# ***SERVICE PROCEDURE***

19518R1  
JANUARY, 2020

**SUBJECT:** SAFETY RECALL  
Stationary PTO on certain International® HV™ and MV™ Series, DuraStar®, and WorkStar® models built 12 January 2017 thru 24 September 2019 with feature code 12VXT (Engine Speed Control; Electronic, Stationary, Variable Speed) or 12VXU (Engine Speed Control for PTO; Electronic, Stationary Preset, Two Speed Settings)

**Figure 1. PTO Parameters**

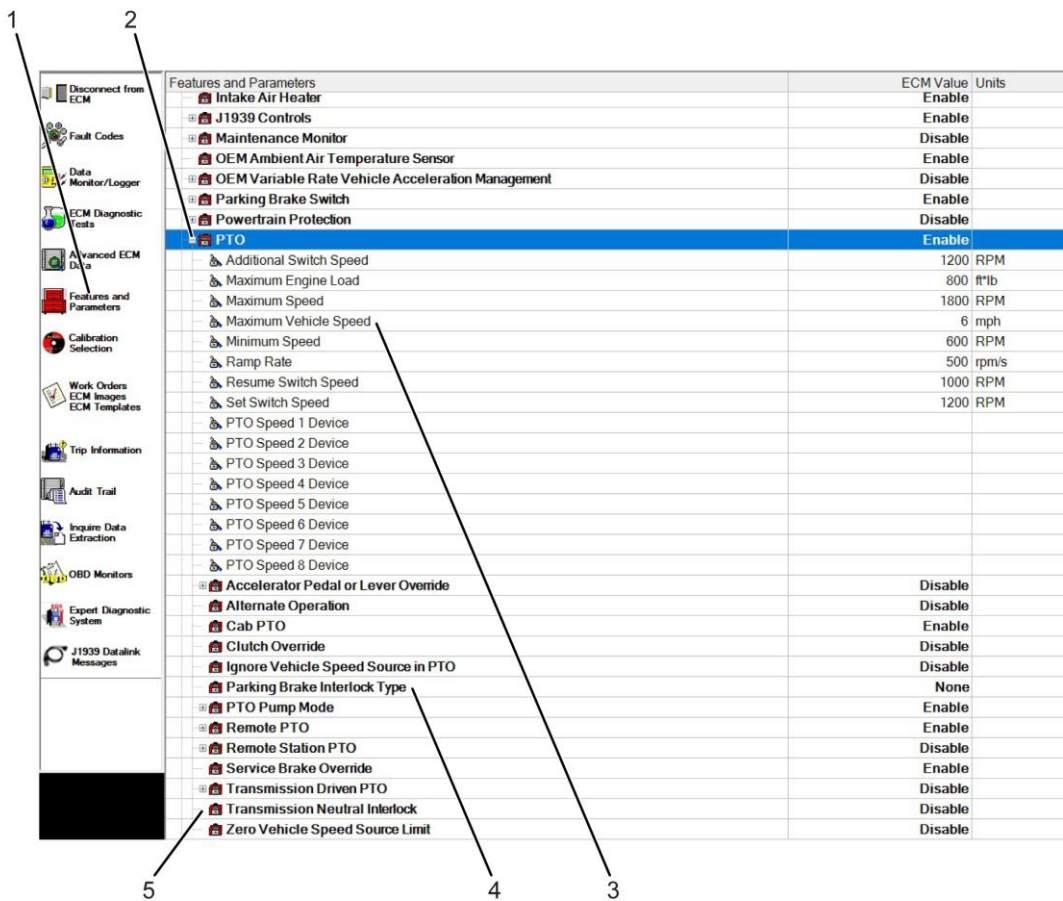
On certain trucks equipped with an automatic transmission, if the automatic transmission is still in drive or reverse position and the stationary PTO switch is engaged, the engine rpm could ramp up and may overcome parking brake hold capability resulting in possible vehicle movement. Unexpected movement of the truck can increase the risk of a crash resulting in property damage or personal injury.

- a. Maximum Vehicle Speed: 2 mph (3.2 km/h) (Figure 1, Item 3).
- b. Parking Brake Interlock Type: ALL (Figure 1, Item 4).
- c. Transmission Neutral Interlock: ENABLE (Figure 1, Item 5).
